SUBJECT: NRC AUGMENTED INSPECTION TEAM (AIT) REGARDING THE
FAILURE OF THE EMERGENCY DIESEL GENERATOR LOAD
SEQUENCERS NRC INSPECTION REPORT 50-412/93-81

U. S. NUCLEAR REGULATORY COMMISSION
REGION I
AUGMENTED INSPECTION TEAM REPORT

INSPECTION OF EMERGENCY DIESEL GENERATOR
LOAD SEQUENCER FAILURES

REPORT/DOCKET NOS. 50-412/93-81

Figure 1

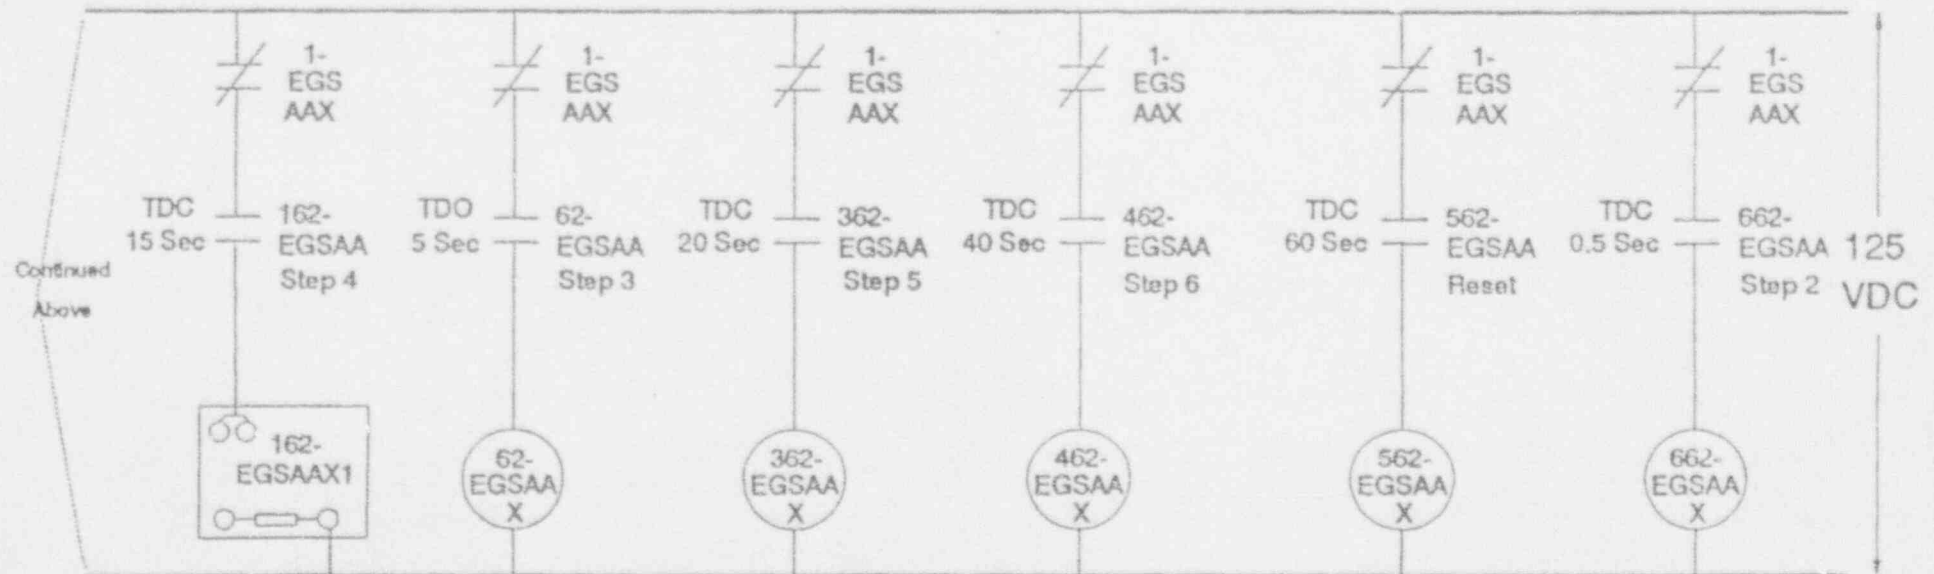
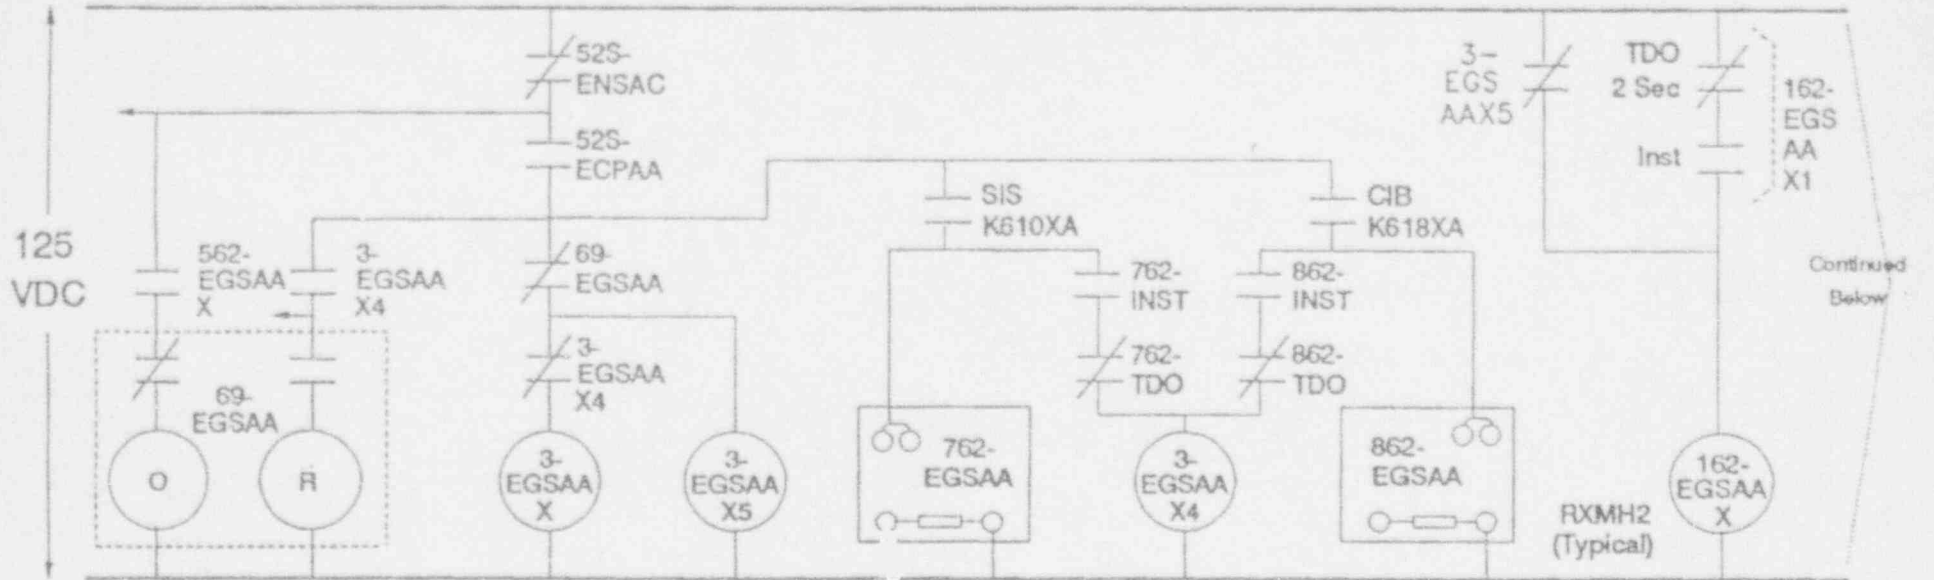
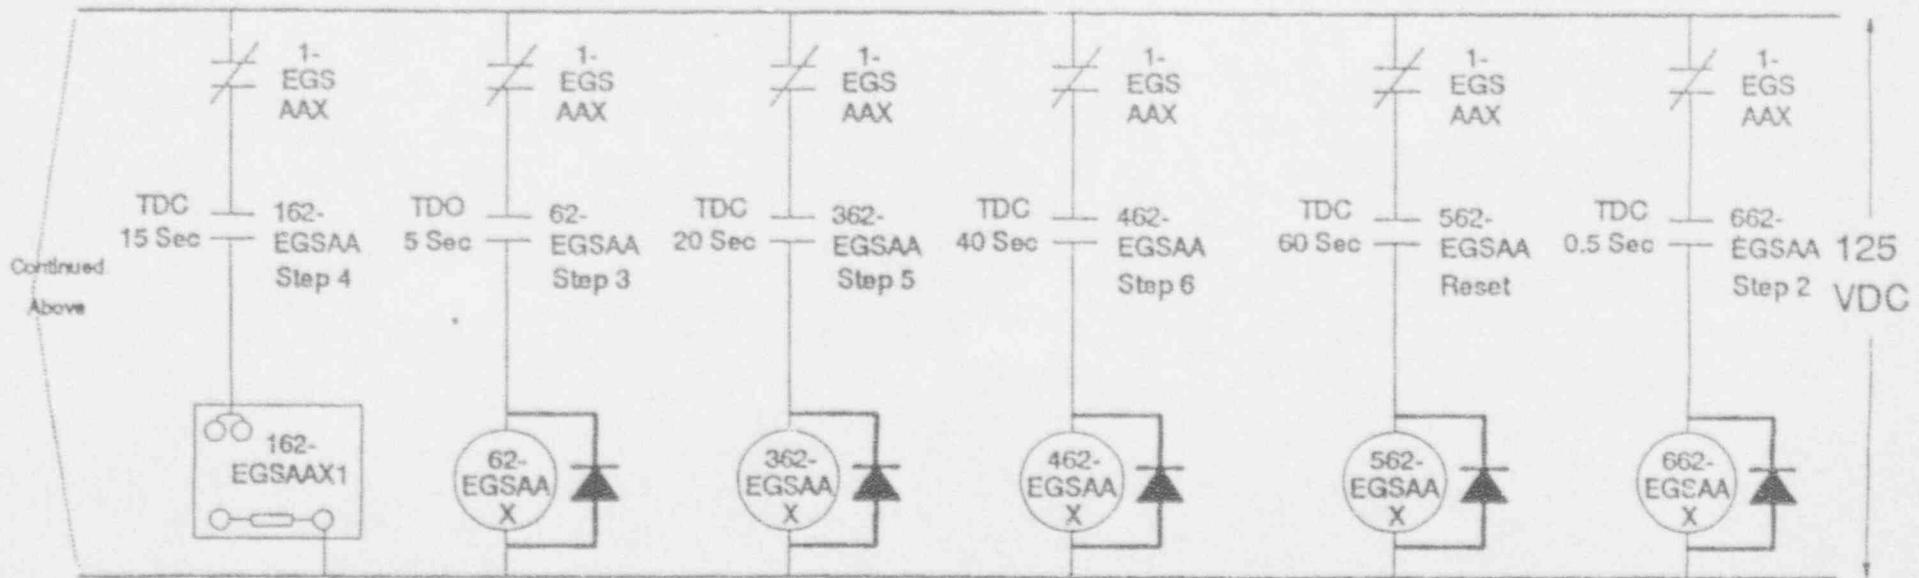
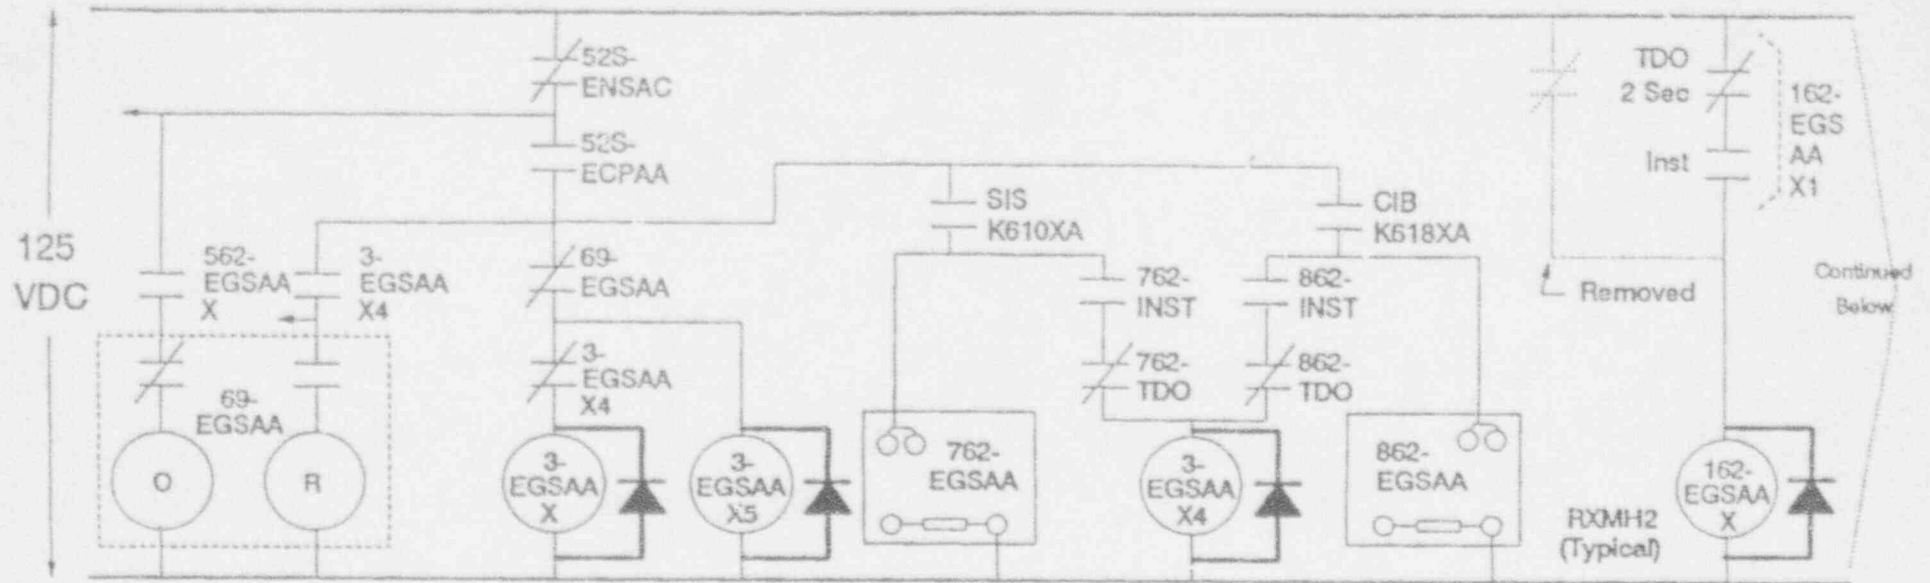
The cause of the load sequencer failure was determined to be the malfunction of the safety injection microprocessor timer/relay (762-EGSAA) that is used for sequencer reset. Specifically, the microprocessor timer/relay time delay contact opened after a 1/2 second time delay and then inadvertently re-closed a very short time later (approximately 30 milliseconds). Closing of the 762-EGSAA time delay contact energized the 3-EGSAAX4 relay, which "locked-out" (deenergized) the load sequencer master relay and prevented further load sequencer operation.

The diagnostic test equipment also identified that a large negative voltage spike resulted from deenergizing the auxiliary relay (3-EGSAAX4) coil. The auxiliary relay coil (3-EGSAAX4) deenergized when the microprocessor timer/relay (762-EGSAA) time delay contact (762-TDO) opened. The spike was generated by the sudden change in current in the auxiliary relay coil (inductor). The rise and fall times of the voltage spike were very fast and the amplitude of the voltage spike was in excess of 1100 volts at the 762-TDO contact. The voltage spike was transmitted back into the input, power line, and electronics of the microprocessor timer/relay (762-EGSAA) by the arc shower process across the 762-TDO contact. The resulting electronic interference caused the microprocessor to malfunction and reclosed the 762-TDO contact.

Minor design change package (MDCP) number 2057 was developed to prevent the malfunction of microprocessor timer/relays 162-EGSAAX1, 762-EGSAA, 862-EGSAA, 162-EGSBAX1, 762-EGSBA and 862-EGSBA, while the microprocessor timer/relays are deenergizing their respective auxiliary relays. This was accomplished by the installation of inductive voltage transient suppressors across nine auxiliary relay coils in each sequencer train. The sequencer timer/relays and auxiliary relays are located in power panel PNL*SEQ244 for Train-A and in power panel PNL*SEQ254 for Train-B. The applicable portions of the schematics showing the pre-modification and post-modification configurations of the EDG loading sequencer are provided in Figures 1 and 2 of this inspection report, respectively.

The suppressors consisted of diodes which were installed in parallel with the auxiliary relay coils to suppress the voltage spikes created when the relay coils are deenergized. The suppressor type selected was an ABB terminal base mounted, RTXE with the type 2 assembly. These diodes were designed for use with the ABB RXMH-2 type coil relays and other ABB type relays. The purpose of these diodes, as explicitly stated in the published ABB relay data sheets, was "to obtain a dropout delay for dc relays or to protect electronic circuits against transients."

After the failure of the functional test, the licensee reviewed the AFW pump starting circuit to determine why the AFW pump inadvertently started at sequencer step 1 rather than at step 4. During step 1 of the loading sequence, the safety injection (SI) contact in the AFW pump starting circuit was closed. The two additional contacts in the starting circuit were the 162-EGSAAX contact from the sequencer and the voltage available on the emergency bus contact from the bus voltage sensing relays. To prevent premature starting of the AFW pump, the 162-EGSAAX relay must deenergize prior to the voltage available on the bus sensing relays pick-up. This developed a race between the two relays. The installation of the suppressor diodes around the 162-EGSAAX relay caused a delay in the drop-out time of the 162-EGSAAX relay. This delay allowed the emergency bus voltage relay contacts to close prior to the opening of the 162-EGSAAX contacts, thus starting the AFW pump.

The modification which installed the diode suppressors did not assess the effect of the delay in auxiliary relay drop-out time on the sequencer operation. The ~~original~~ safety evaluation identified that the expected delay in relay drop-out was approximately 20 milliseconds. The safety evaluation correctly stated that this would not adversely affect the overall delay time in loading safety-related equipment. However, the safety evaluation did not document the effect that this would have on the AFW pump start circuit. In addition the functional test measured the actual delay in relay drop-out time to be approximately 70 milliseconds.

In response to this failure, the licensee performed a detailed review of the sequencer circuit and verified that no other potential start logic problems existed. In order to correct the failure associated with the AFW pump starting circuit, the licensee initiated an Engineering Change Notice (ECN) to modify the AFW pump starting circuitry such that the 162-EGSAAX relay would not be energized prior to load sequence step 4. The design change

prevents the possibility of having the three AFW pump starting circuit contacts closed prior to sequencer step 4. The 162-EGSAAX relay would be energized for 2 seconds at step 4 of the load sequence. An additional change to the AFW pump start circuit was required to provide a second AFW pump a start signal after the final sequencer step.
